Y1A, Y1B, Y1C- High-Voltage (HV) Battery Measurements during HV Battery Repair

Models	Model Year	Model Type	VIN Range	Vehicle-Specific Equipment
Taycan	All	Y1A, Y1B, Y1C	All	N/A

Service Information

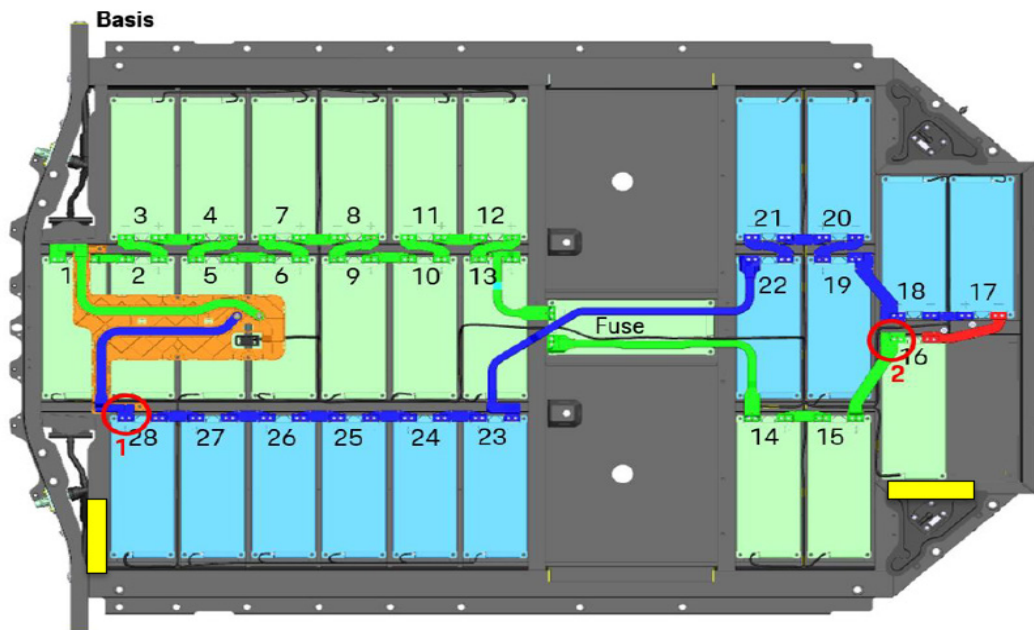
1. Split the battery modules into sections by removing the specified busbars.
2. Perform an IR measurement on the first section.
3. Perform a DST on that section.
4. Perform an additional IR measurement on that section.
5. Move on to the next section.

Flowcharts of this process for each battery variant are available in figures to follow. The end step "Proceed with subsequent work" can refer to the next measurement point or completion of the repair depending on scenario.

Figure 1 - 28-module HV Battery measurement points

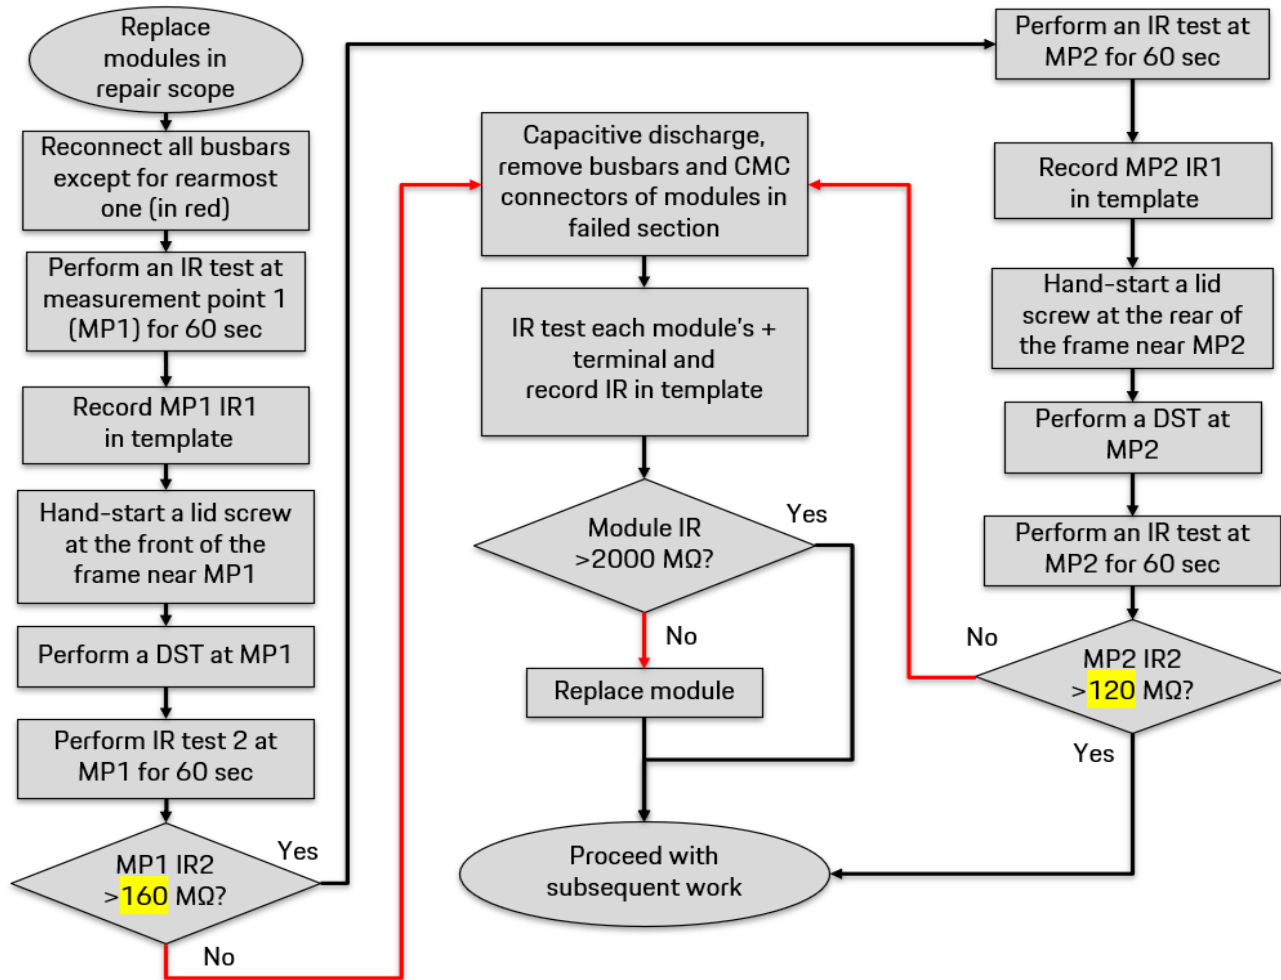
- Suggested grounding points for DST and IR testing on both 28- and 33-module Taycan battery packs have been modified from WM 270803A5 and are detailed below in *figures 1 and 3*.

- Only two DSTs are required on a 28-module battery pack during repair.
- The busbar indicated in red must be removed prior to measurements at either point.

- Perform an IR test at points 1 and 2 before the DST at those points.
- Perform a DST only at points 1 and 2 shown below for each repair scope.
- The yellow boxes in *Figure 1* designate the sections of frame where a lid screw can be hand-started to ground the dielectric strength tester.

- Also perform IR tests at points 1 and 2 after a DST, with the negative probe in contact with a clean spot on the silver frame surface designated by the yellow boxes.

- If the final IR test at **measurement point 1** fails, remove busbars and CMC connections from each module shaded in **light blue** for further IR testing as described in the following *Updated IR Measurement Procedure* sections.

- If the final IR test at **measurement point 2** fails, remove busbars and CMC connections from each module shaded in **light green** module for further IR testing as described in the following *Updated IR Measurement Procedure* sections.

- EXAMPLE: Point 1 passes DST and point 2 fails.
 - Perform IR tests on each light green module in the failing section (In this example, section 2). No additional work is required for the passing modules in section 1.

Figure 2 - 28-module Flowchart

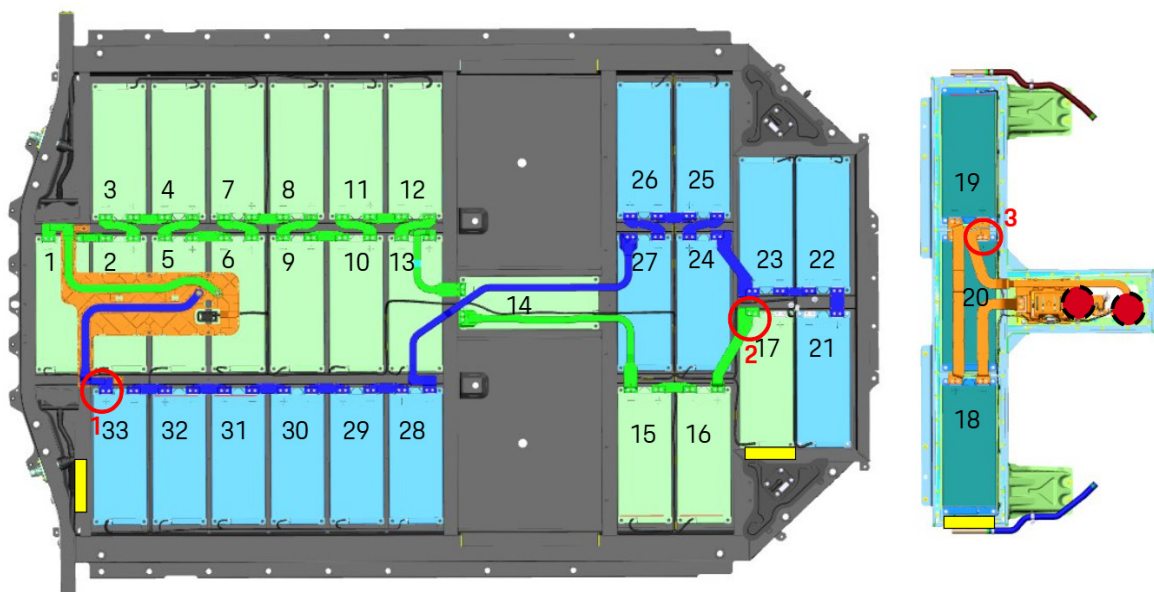
- Perform IR tests at each measurement point in *Figures 1 and 3* before and after a DST at that point.
 - ▷ If the DST passes but IR falls below the thresholds in *Figures 2, 4, and 5*, proceed with IR testing each module.

Figure 3 - 33-module HV Battery measurement points

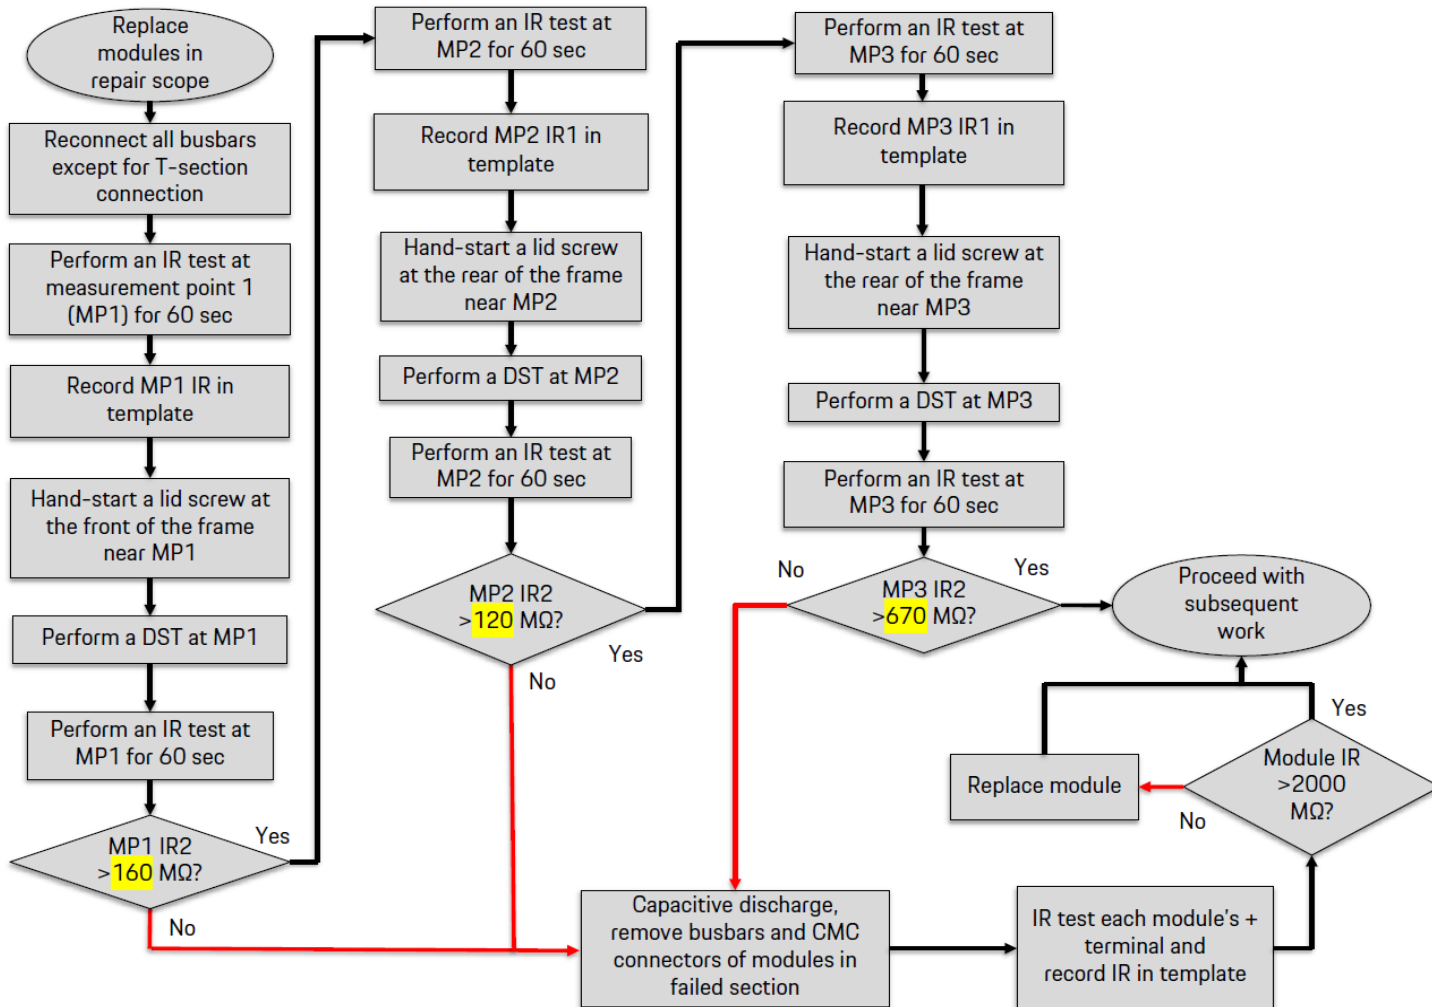
- Only three DST's are required on the 33-module battery pack during repair.
 - Perform a DST only at points 1, 2, and 3 for any repair scope involving the lower-level modules.

- Repair scopes in only the upper "T" section require an initial DST at the mid-pack fuse as shown in step 3.9.3 of Safety test after assembly work on the high-voltage battery with 33 modules in WM 270803A5 instead of point 3 in *Figure 3*.

- If removed, the upper "T" Section should be placed aside on a VAS 6762/44 Insulating mat during testing.
- Perform an IR test at points 1, 2 and 3 before the DST at those points.

- The yellow boxes in *Figure 3* designate the section of frame where a lid screw can be hand-started to ground the dielectric strength tester. If performing a DST on the mid-pack fuse, use the location on the upper "T" section to ground the negative clamp.

- Perform IR tests at points 1, 2, and 3 after a DST, with the negative probe in contact with a clean spot on the silver frame surface designated by the yellow boxes.

- If the final IR test at **measurement point 1** fails, remove busbars and CMC connections from each module shaded in **light blue** for further IR testing as described in the following *Updated IR Measurement Procedure* sections.

- If the final IR test at **measurement point 2** fails, remove busbars and CMC connections from each module shaded in **light green** for further IR testing as described in the following *Updated IR Measurement Procedure* sections.

- If the final IR test at **measurement point 3** fails, remove busbars and CMC connections from each module **in the upper "T" section** for further IR testing as described in the following *Updated IR Measurement Procedure* sections.

- **EXAMPLE:** It is possible for battery to have point 1 pass, point 2 pass, and point 3 fail the DST. It would then only be required to perform further IR tests on each module in the upper "T" section. No additional work would be required for the passing lower sections.

- ▷ These measurement points identified below the mid-pack fuse in *Figure 3* serve as alternates to MP1 and MP2 as referenced in the *Figure 5* flowchart when the lower lid is still installed.

Figure 6 - IR Test at Positive Terminal

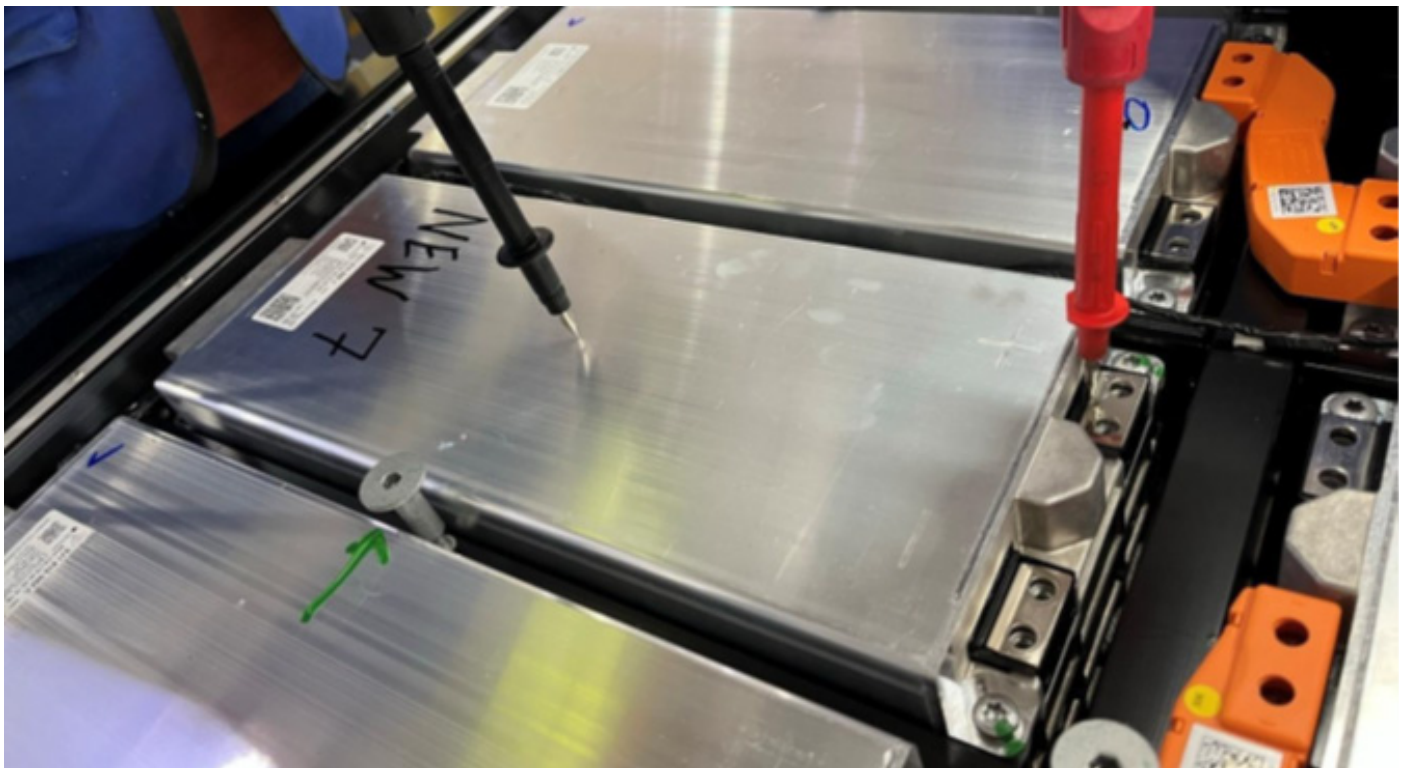
Module IR Testing Procedure: Positive Terminal (Figure 6)

- Place the red probe at the edge closest to the black plastic surrounding the terminal to avoid scratching the conductive surface.
 - CAUTION: pay attention to the angle of the red probe in this case. Avoid contact with the side of the probe and the edge of the module housing. Use a plastic probe cap to expose only the tip of the probe if available.
- Maintain contact with the black probe to the module case in the center. Ensure that the module casing surface is clean at the point of contact.
- The equipotential bonding cable is not suitable as a ground point during this test. Use both straight probes directly on the module to isolate conductive influences.

Figure 7 - Insulation resistance measurement in PIWIS Tester

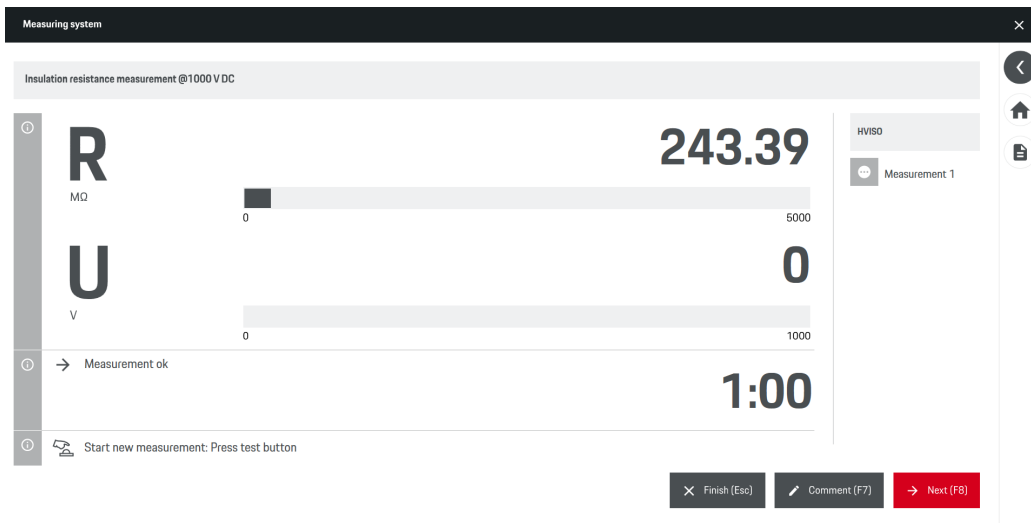
IR Testing Pass/Fail Criteria (Figure 7)

- Shown below is an example of passing test result after 60 seconds of measuring time. This reading can still be displayed as >5000 MΩ when IR measures above the internal software measuring threshold.
- If any module terminal IR test shows a number below 2000 MΩ after 60 seconds of continuous measuring time, this is considered a failure.
- If IR is below the minimum measurement threshold, the IR test won't complete in the measurement equipment display. If the IR test fails to produce a value after multiple attempts on any module terminal, replace it.
- Document any failures in the "Module insulation Resistance Template" Excel file attachment and attach to the repair PCSS entry.
